Title:                   Advisory Committee on Reactor Safeguards  
                              Regulatory Policies and Practices

Date:                  Wednesday, October 18, 2017

Summary of Report Updates in Response to  
ACRS Member Comments from Prior  
Subcommittee Meetings.....89

# Focused Safety Valve Study

**Figure I-1 Cumulative pressurizer safety valve open area fraction versus total number of safety valve cycles, where early containment failures are shown in red\*\***

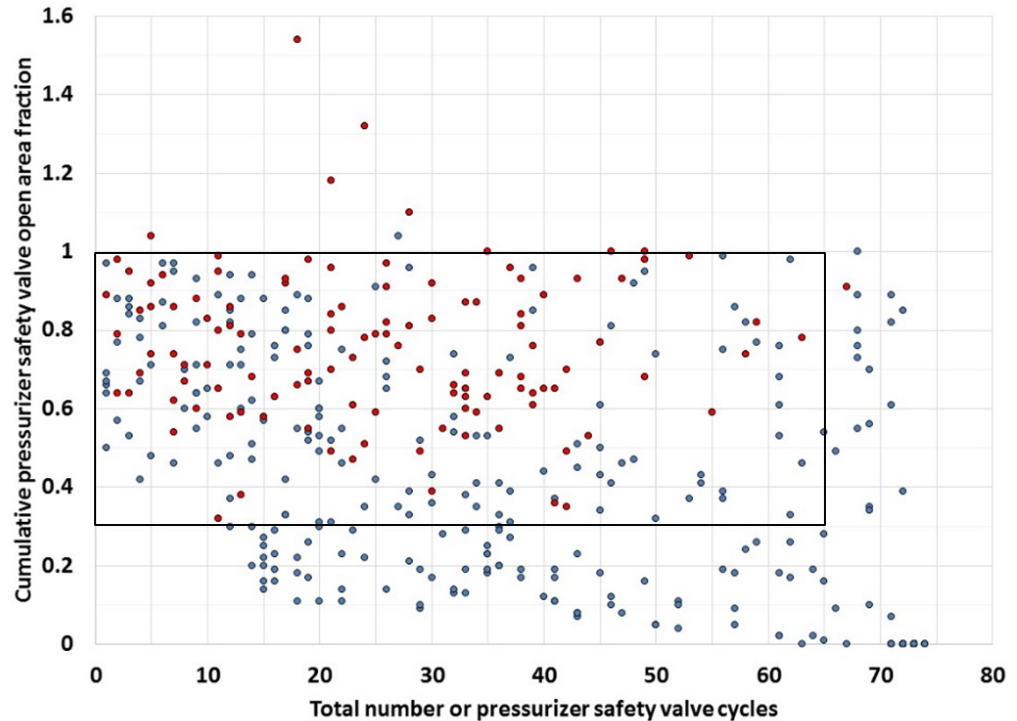
15 In particular, I look at your fifth-order  
16 polynomial fit to the valve failure rate for the valve  
17 data in Figure I-2.

18 The second part of it is when you do the  
19 differentiation of that curve to get the density  
20 function in Figure I-3, that density function does  
21 indeed start out at 1.83e to the -3, at a value of 1.

1           So, I want to make sure that the actual  
2           sampling used the correct probability for failure on  
3           the first demand, that it didn't use 1.83e to the -3,  
4           that it used something between 2 and 3e to the -2 in  
5           the actual runs that you made.

11 MEMBER BLEY: Just maybe Figure I-3, which  
12 is the density function, was drawn without showing the  
13 delta function either.

16 MEMBER BLEY: Maybe it's just the way you  
17 drew the Figure, and you didn't show that three minus  
18 two, right, at one.

21                   MS. GHOSH: So, I think we're going to  
22 take your comment and re-check the numbers after this  
23 meeting, because we're not going to be able to resolve  
24 it right here.

13 MS. GHOSH: But I think in terms of the  
14 larger question of the exact numbers, we'll have to  
15 get back to you on that and we'll double-check.
